GPU NUCLEAR CORPORATION  
SAXTON NUCLEAR EXPERIMENTAL CORPORATION  
APPENDIX A: TECHNICAL SPECIFICATIONS TO  
AMENDED FACILITY LICENSE NO. DPR-4

ATTACHMENT G  
EXPLANATION OF APPENDIX A REVISION  
PAGES 1 TO 4

In connection with their application to transfer management-related authority for the Saxton Nuclear Experimental Corporation facility (Saxton facility) from the Saxton Nuclear Experimental Corporation (SNEC) to GPU Nuclear Corporation (GPU Nuclear), and to amend the Saxton facility license, SNEC and GPU Nuclear propose that the following revision be made to the Saxton facility's Technical Specifications:

Figure 2

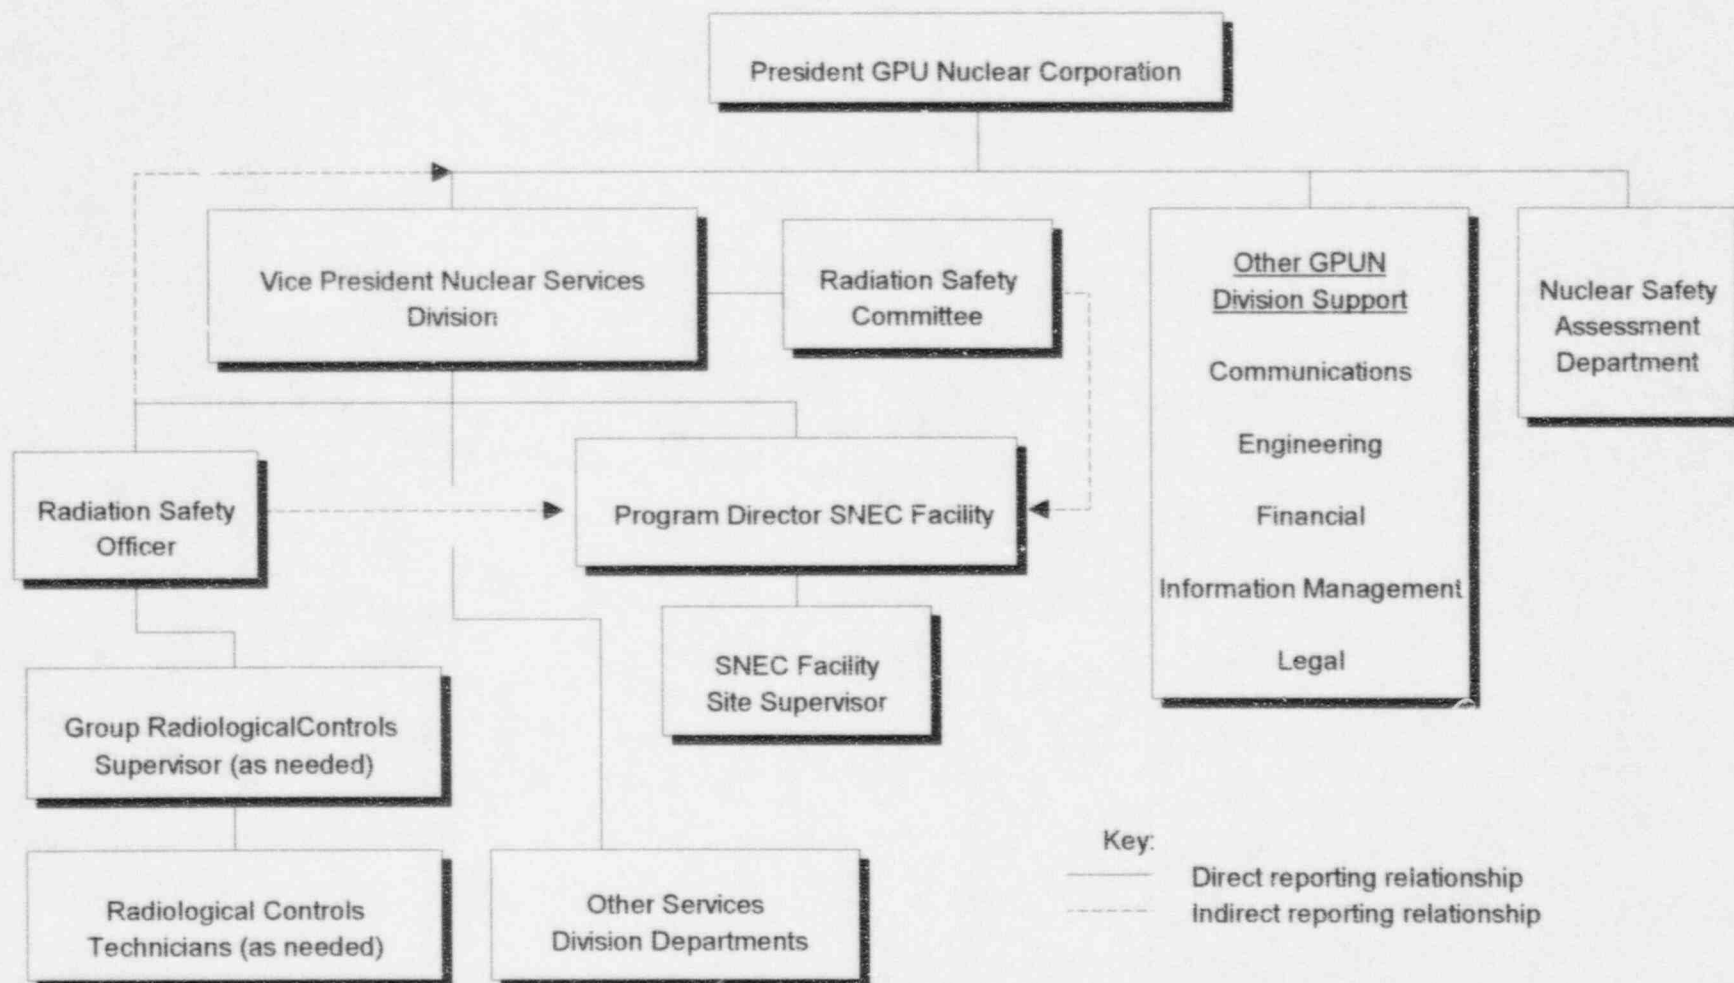
Figure 2 changes:

1. With the transfer of management responsibilities to GPU Nuclear, the SNEC Board of Directors and President SNEC are eliminated from the organization chart.

2. The Vice President NSD is included in the organization chart since the Program Director SNEC Facility reports directly to the position. Various NSD departments provide services in support of Saxton facility activities. They are direct reports and are indicated in a new box, titled "Other Services Division Departments". Note that these departments (Environmental, Human Resources, Regulatory Affairs and Training) are not specifically identified. They are intentionally omitted to preclude the need for additional Technical Specification changes based on a position name change or reporting change within the Division.

3. The Radiation Safety Committee reports directly to the Vice President NSD and maintains an indirect reporting relationship with the Program Director SNEC Facility, encouraging communication between the Committee and site management.

4. The Radiation Safety Officer reports directly to the Vice President NSD and is tied via an indirect reporting relationship to both the President GPU Nuclear and the Program Director SNEC Facility to encourage communication among the positions.

5. The box previously labeled Technical Support identified GPU Nuclear departments and depicted them as reporting directly to the President GPU Nuclear. They in fact are departments of other GPU Nuclear divisions (besides NSD) which in turn report directly to the President GPU Nuclear and provide activities in support of the Saxton facility. The box has been renamed Other GPU Nuclear Division Support to more correctly identify the relationship.

These changes are administrative and allow resources supporting activities at the Saxton facility to work within the existing framework of the GPU Nuclear organizational structure. Allowing the administrative changes, in connection with the transfer to GPU Nuclear of management responsibilities under the Saxton license, helps to ensure enhances the success of the remaining characterization and the decommissioning efforts by permitting direct and effective utilization of GPU Nuclear's experience.
